RE: REVISED DRAINAGE PLAN FOR LOTS 1 - 4 OF WASHINGTON BUSINESS PARK
(C-17/D1U4) REVISION DATE OF APRIL 21, 1988

DRAINAGE / GRADING PLAN
WASHINGTON BUSINESS PARK
 SHEET 1 OF 1

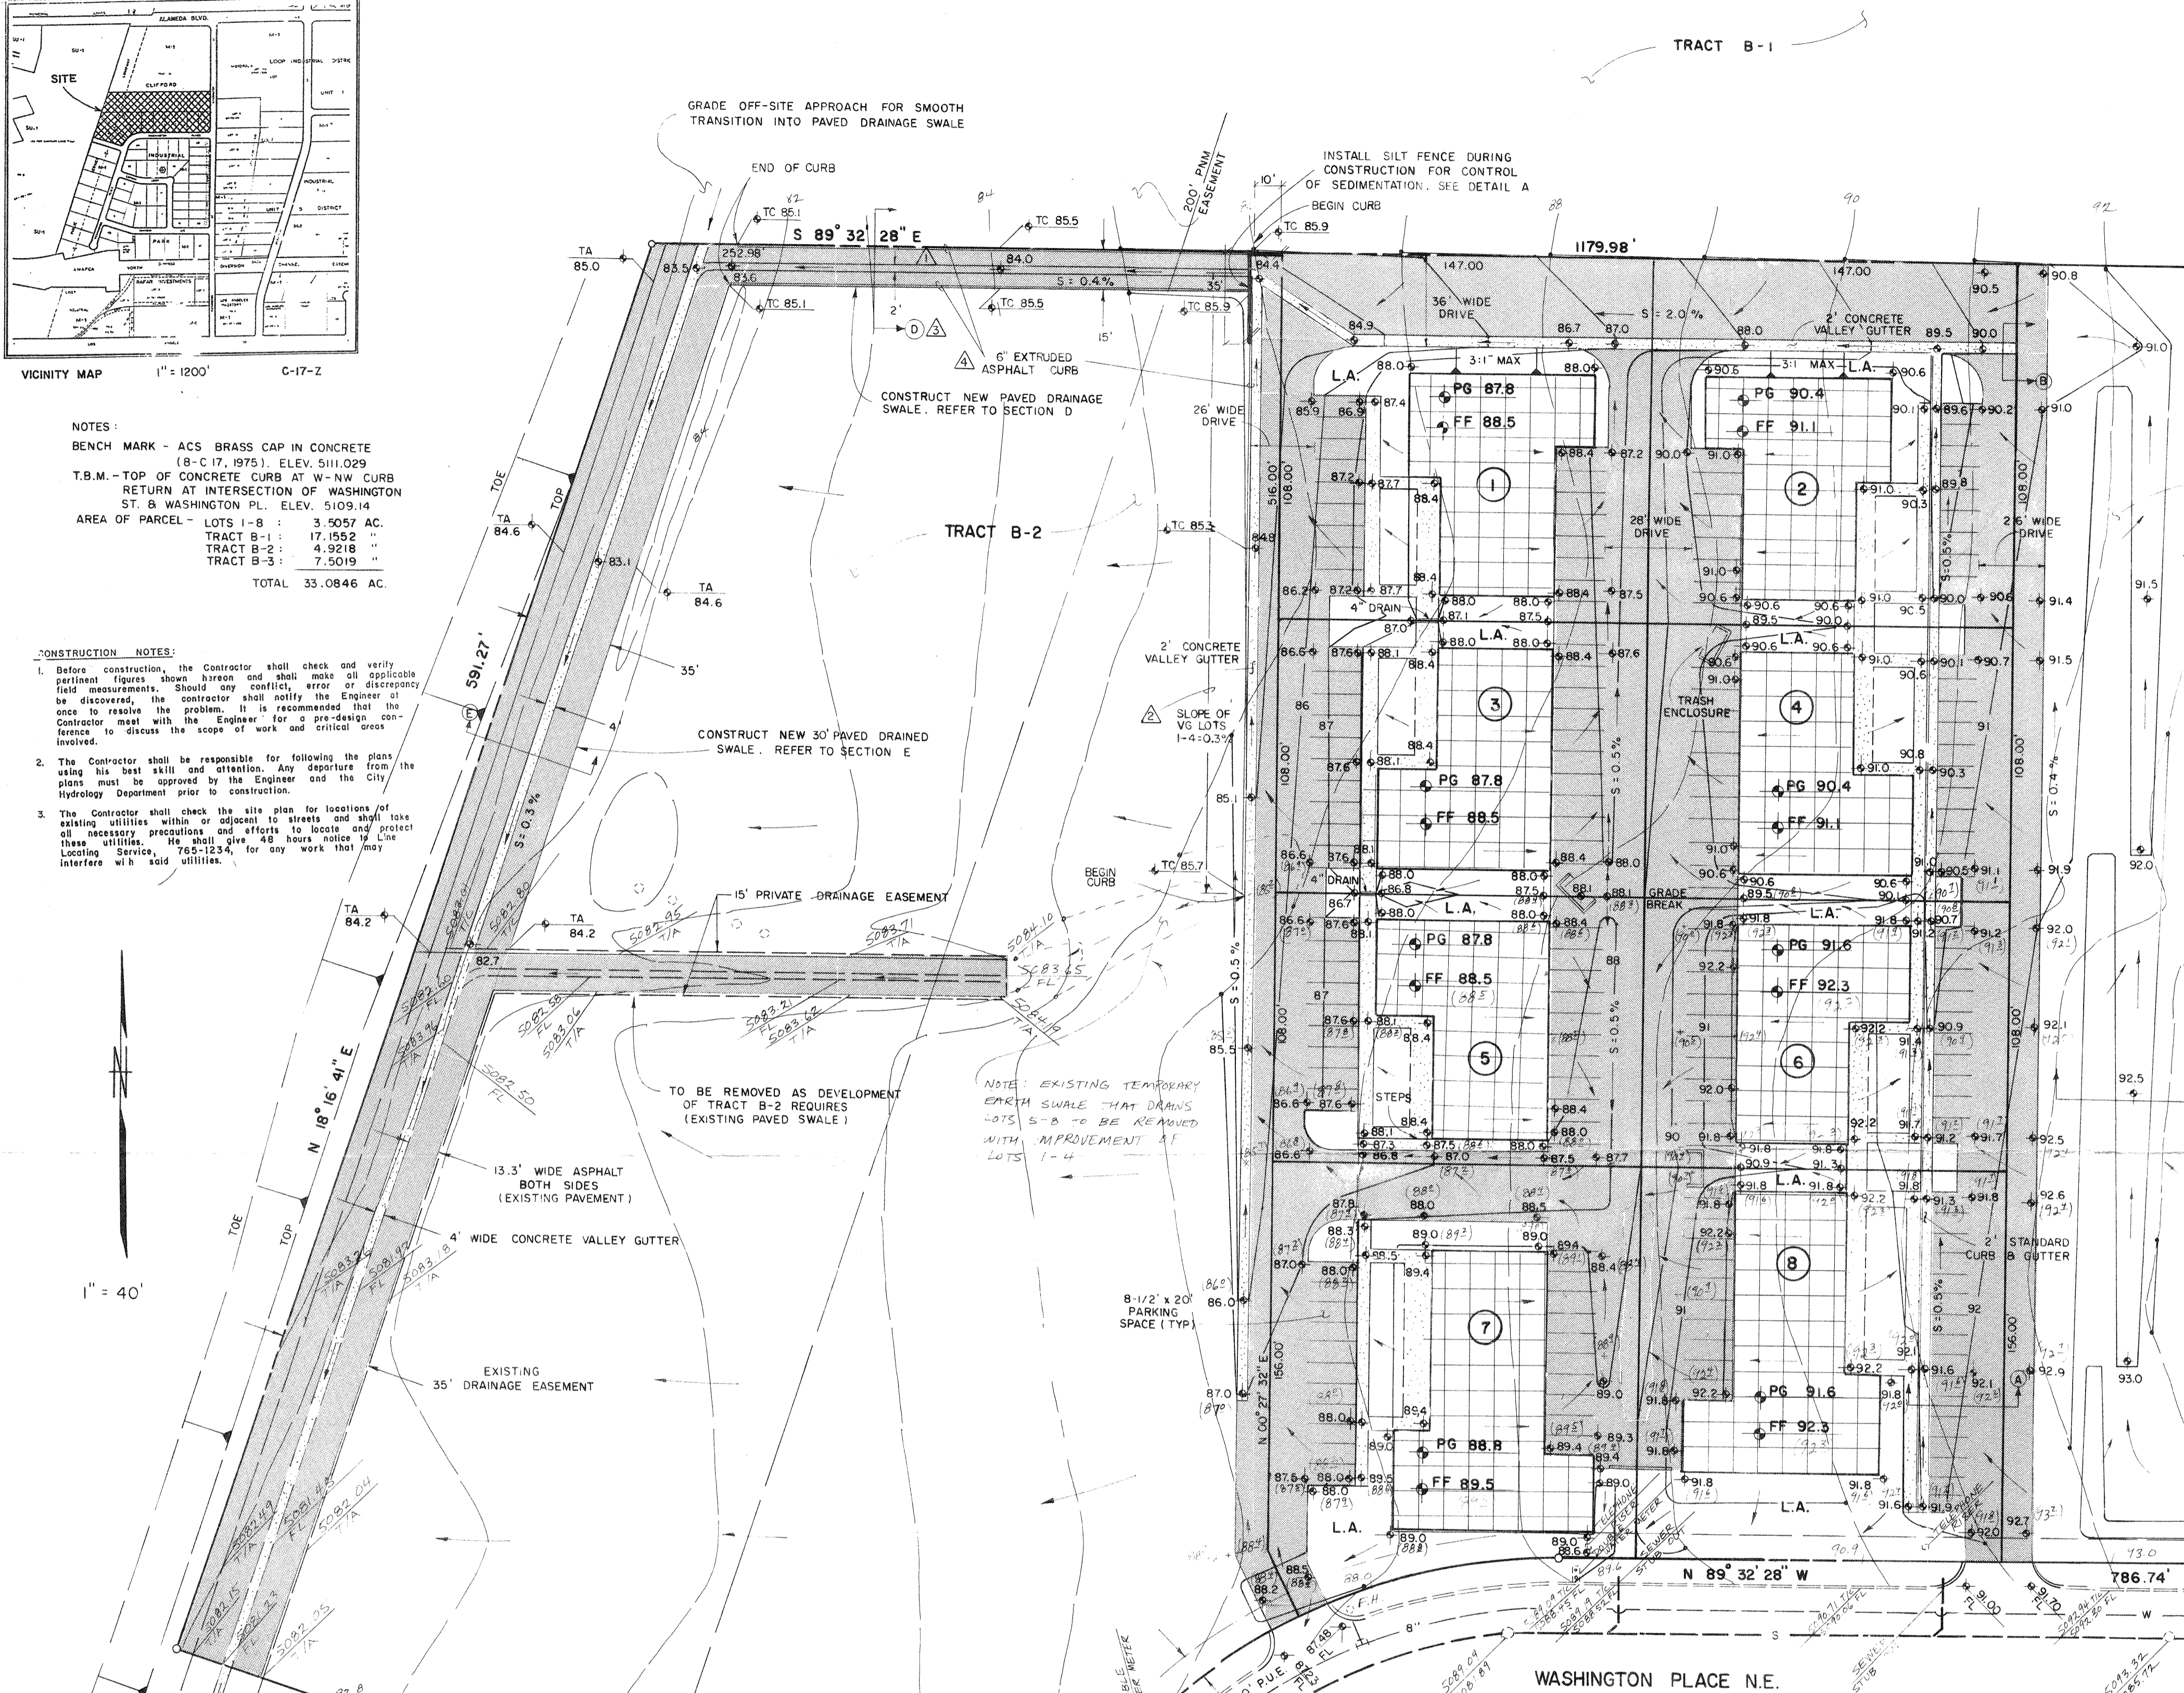
Based on the information provided on your resubmittal of April 21, 1988, revisions as indicated are acceptable for Building Permit approval.

Please be advised that when final certification for Lots 1 through 4 is submitted, items listed on my March 4, 1988 letter to you will need to be addressed.

RESUBMITTAL - 4-21-88:
 REGRADE PRIVATE DRAINAGE SWALE
 REGRADE WEST VALLEY GUTTER
 REVISE SECTION B CALCULATIONS FOR DRAINAGE SWALE
 INSTALL EXTRUDED ASPHALT CURB
 CHRIS WEISS, P.E. DATE
